**HIGH TECH CORRIDOR DEVELOPMENT, LLC
HARRISON COUNTY, WEST VIRGINIA**

WHITE OAKS PASE II A

ADDENDUM #3

NOVEMBER 2, 2022

ISSUED FOR BID PLANS FOR
WHITE OAKS BUSINESS PARK
PHASE II A
BRIDGEPORT, WEST VIRGINIA
SUMMARY OF QUANTITIES

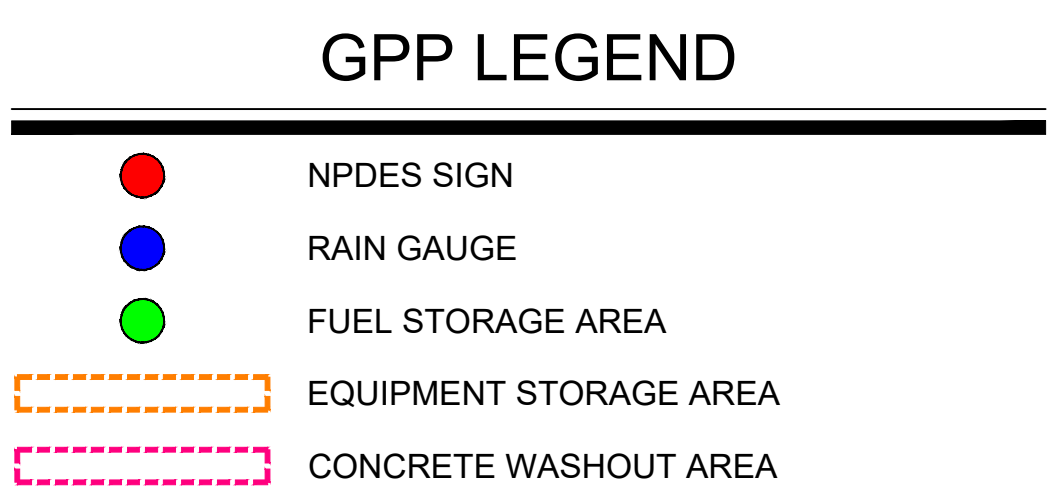
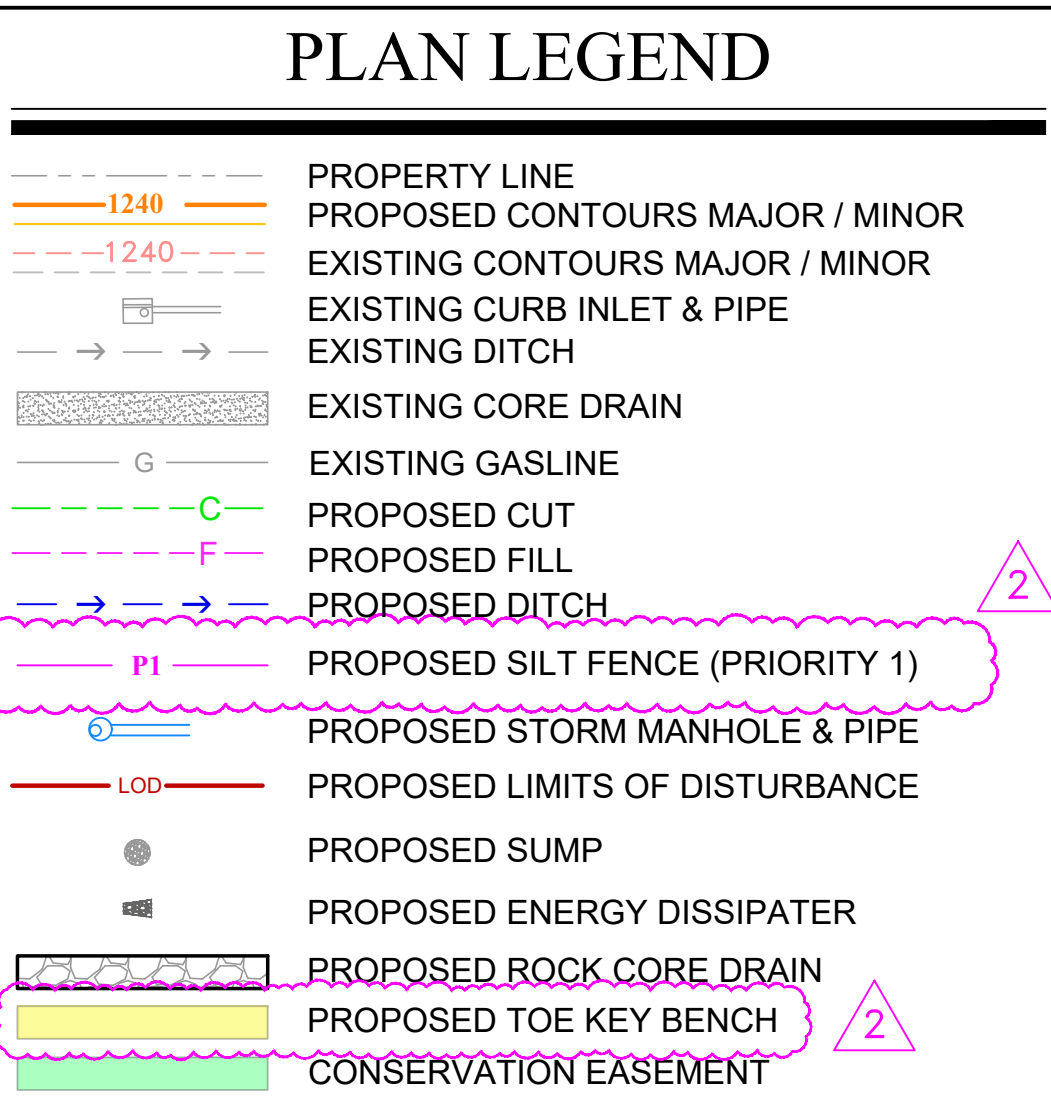
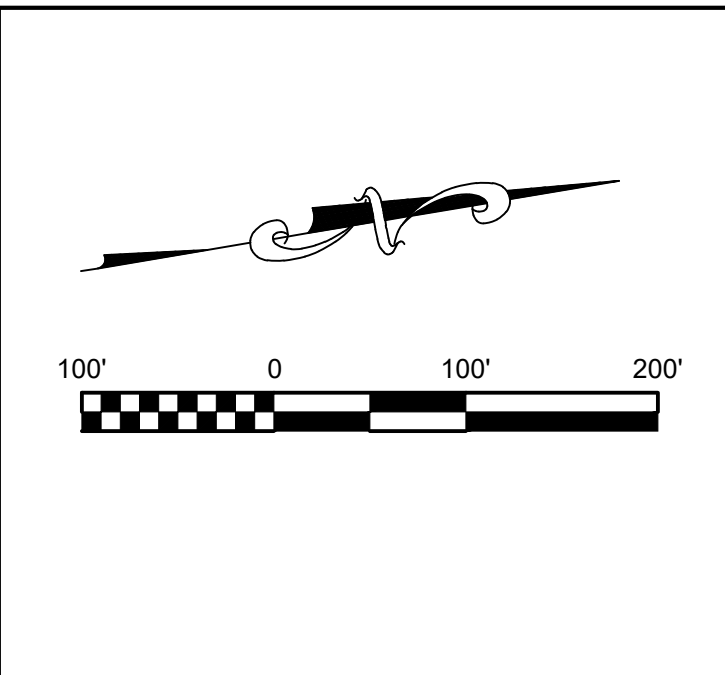
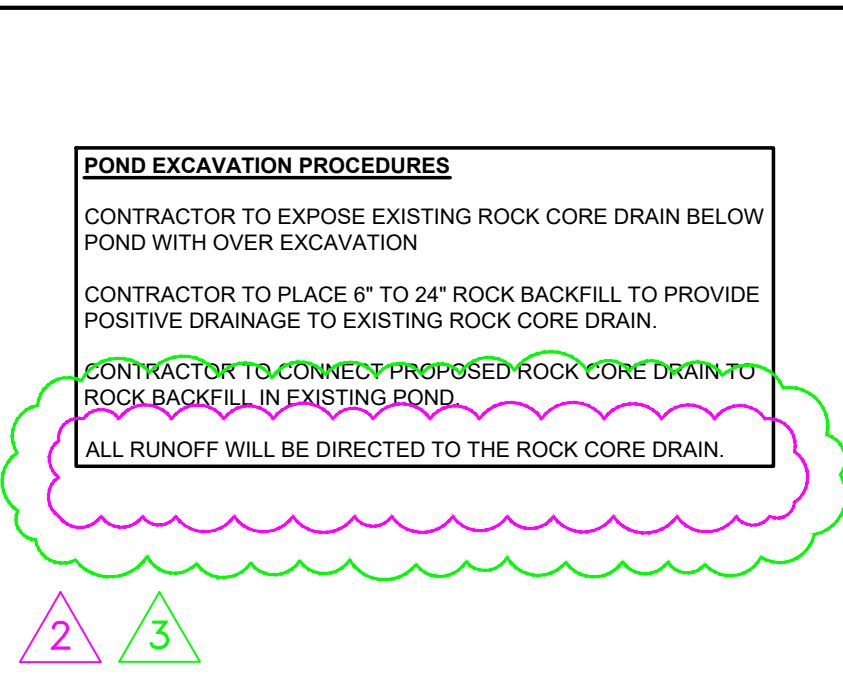
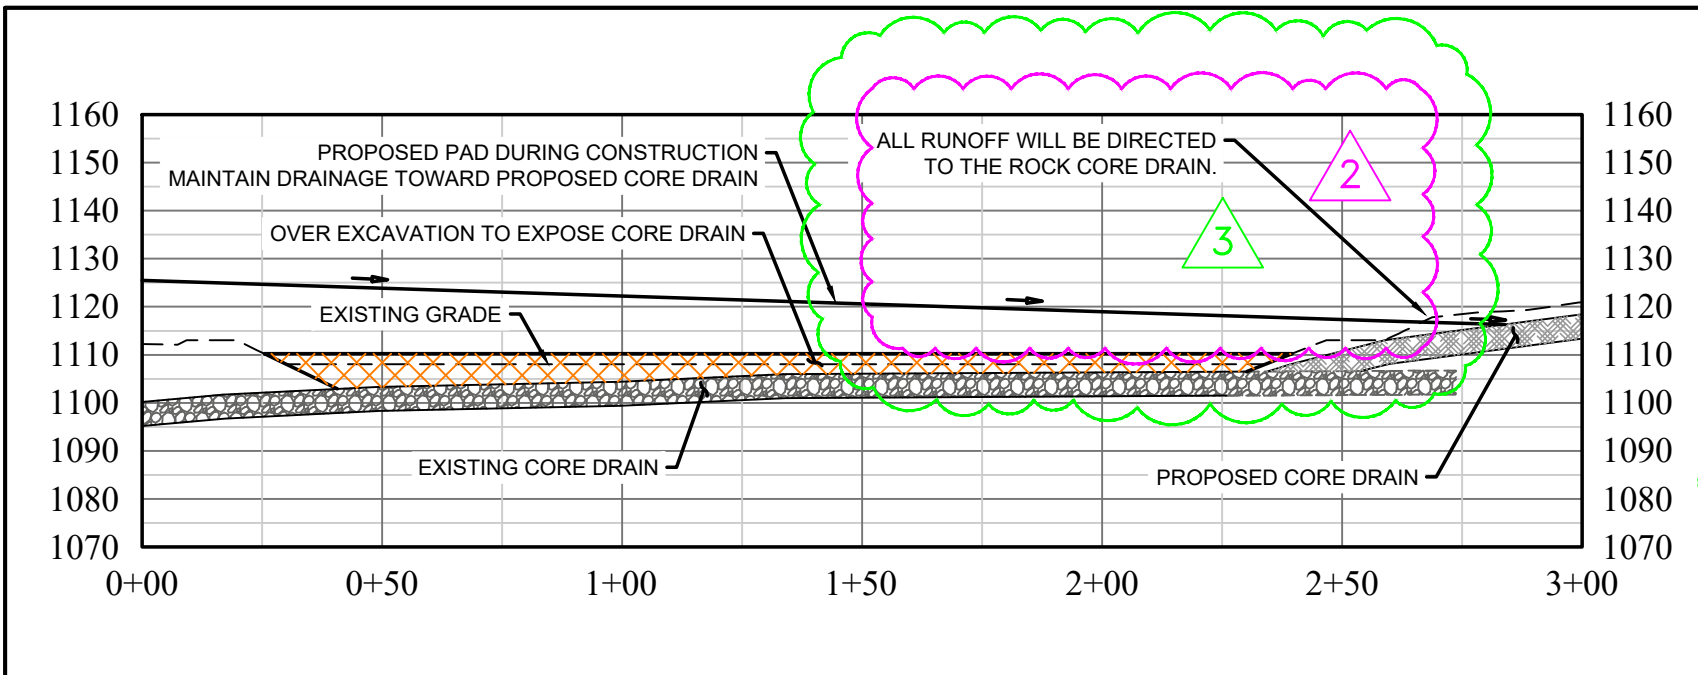
3	DJW	10/27/22	Removed CFS Sediment Trap, fixed item #'s & OSF Unit
2	JCP	10/26/22	Revised Quantities-3" gas removed, CFS trap & Sumps added
1	JCP	10/19/22	Revised quantities
NO.	BY	DATE	DESCRIPTION

ISSUED FOR BID PLANS FOR
WHITE OAKS BUSINESS PARK
PHASE II A
BRIDGEPORT, WEST VIRGINIA
ESC GRADING PLAN - STAGE 2

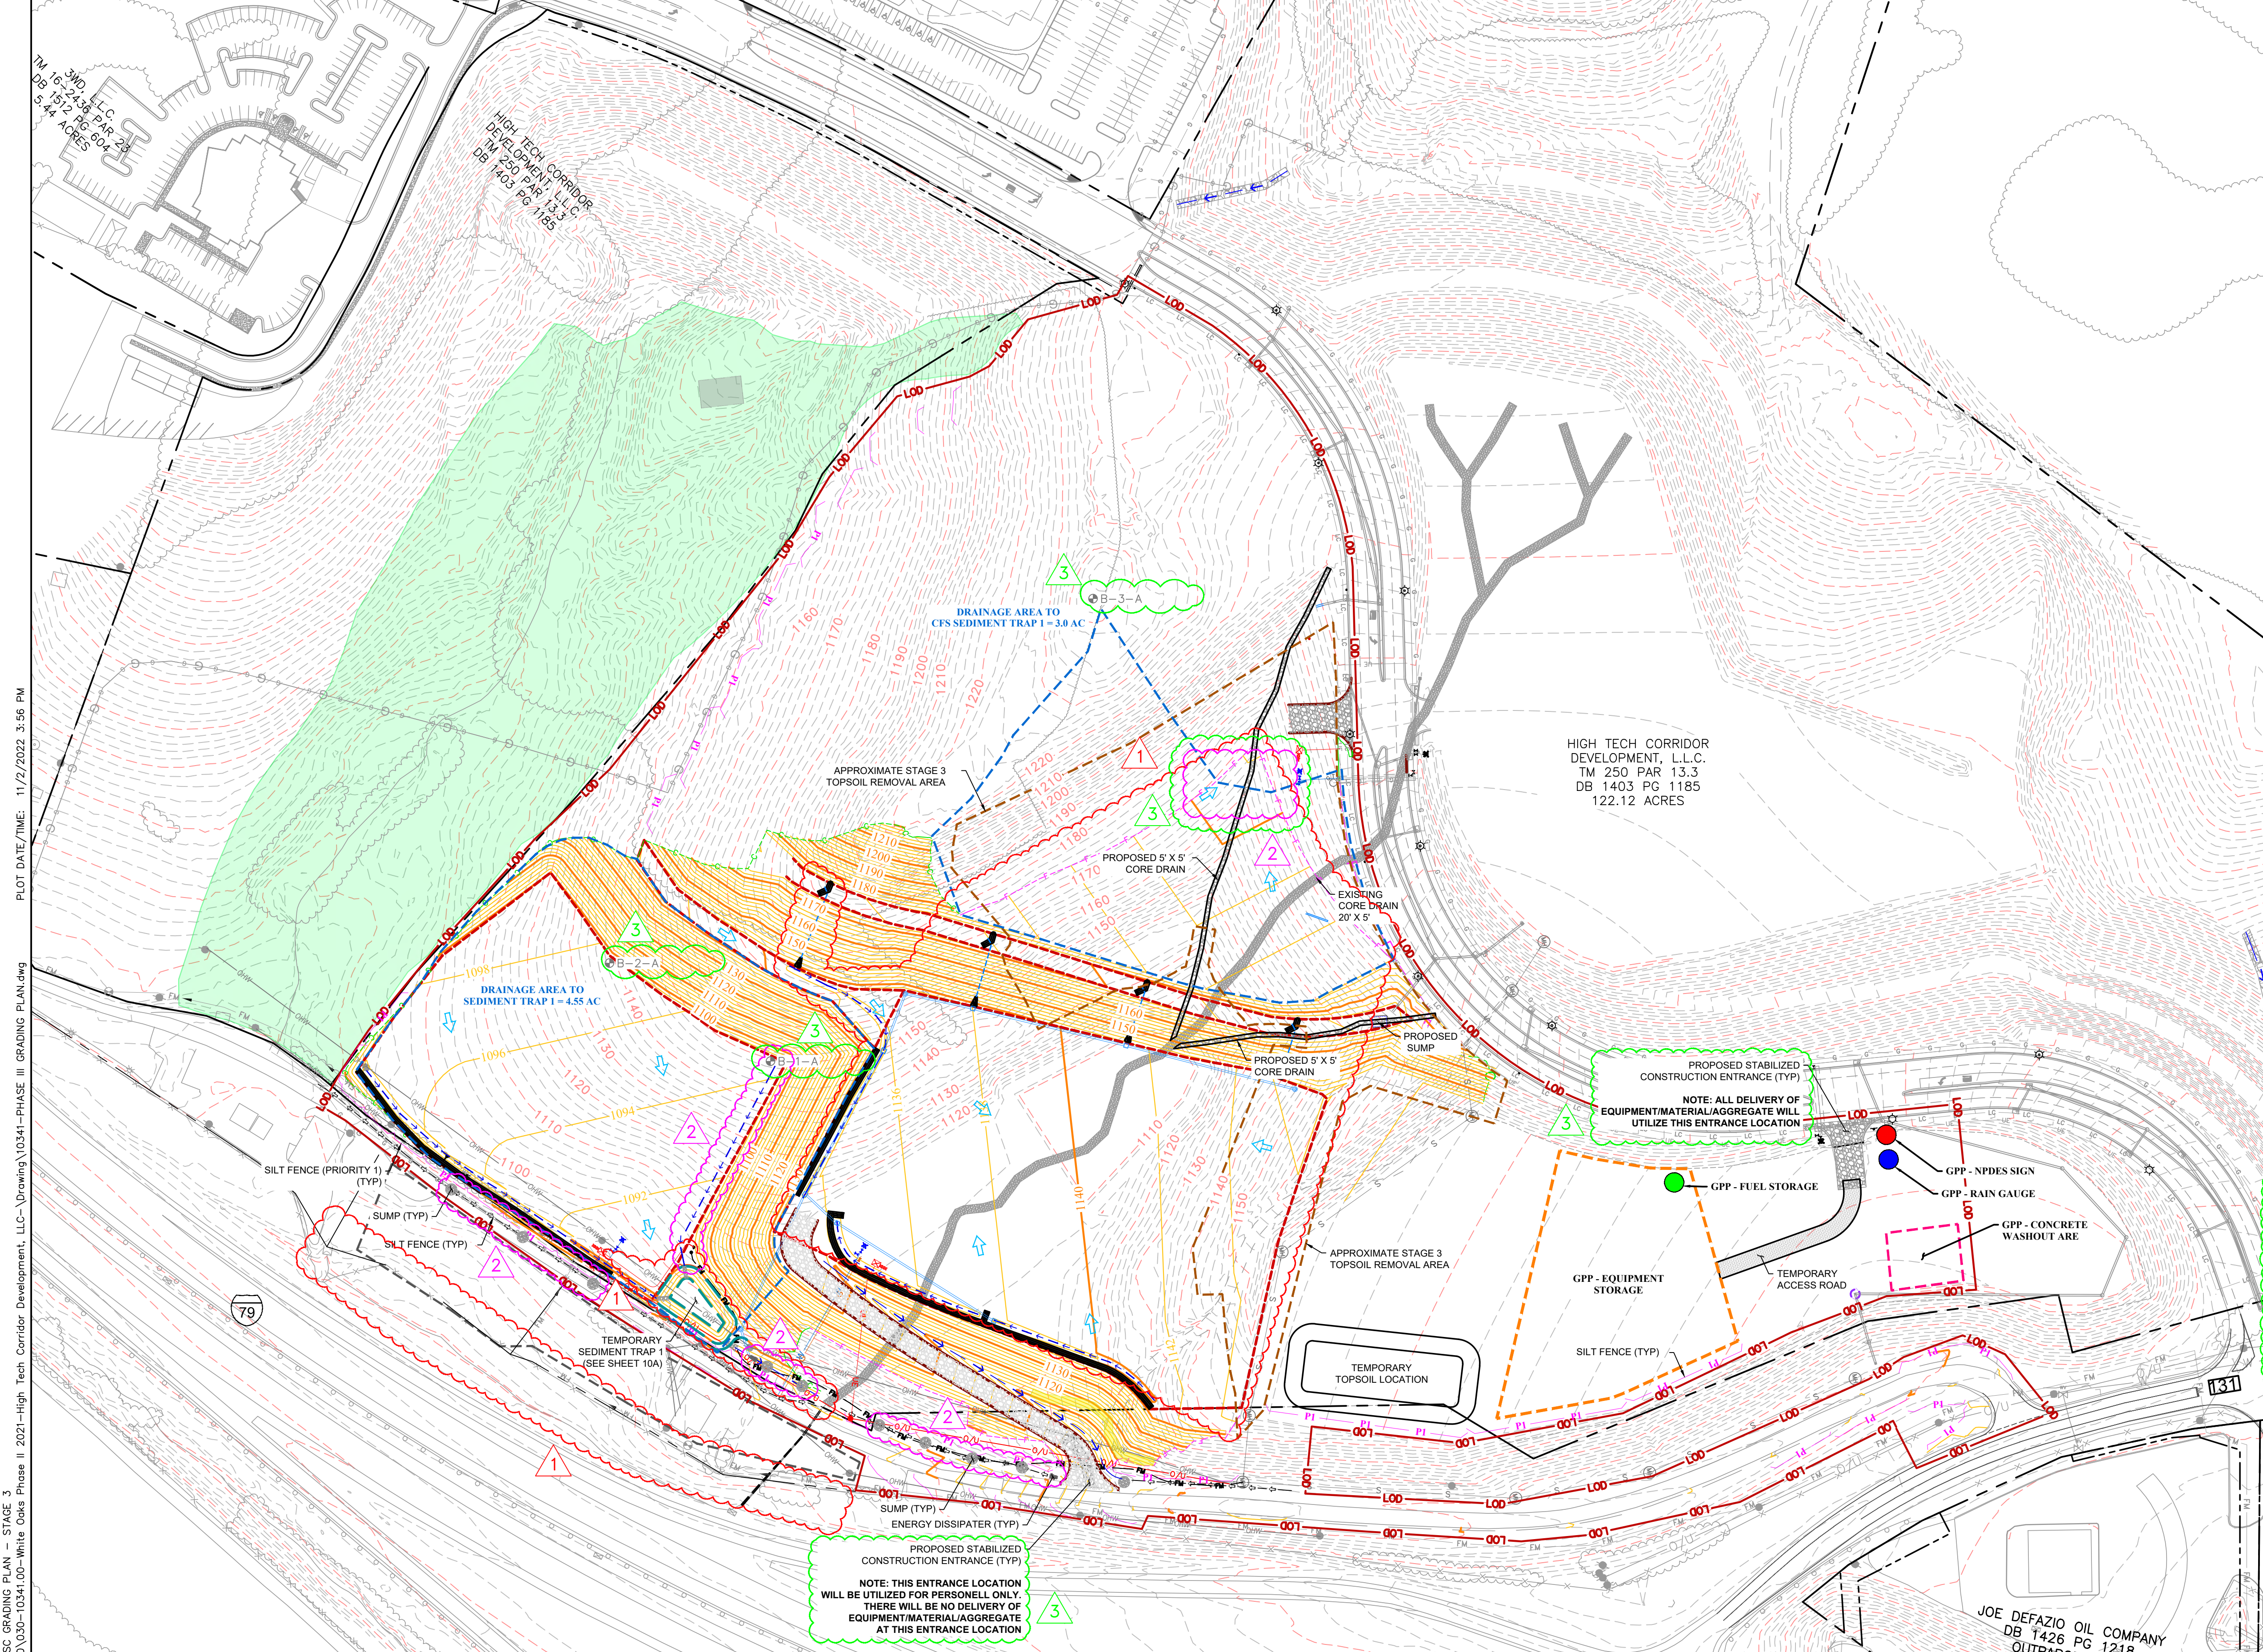
1. The Compost Filter Sock Trap on Pad 2 has been removed from the plans as per WV DEP comments on the NPDES permit. The permit has since been issued based upon the plans shown in this Addendum.

3	DJW	10/27/22	Remove Compost Filter Sock Trap, Stabilized Construction Entrance Note Added
2	DJW	10/24/22	Replaced Sump With Compost Filter Sock Sediment Trap
2	DJW	10/24/22	Revised Silt Fence To Priority 1, Added Energy Dissipaters
2	DJW	10/19/22	Added Sumps Within Wildlife Lane Ditchline
1	JCP	10/19/22	Adjusted Sed Trap 1, Revised Earthwork
NO.	BY	DATE	DESCRIPTION
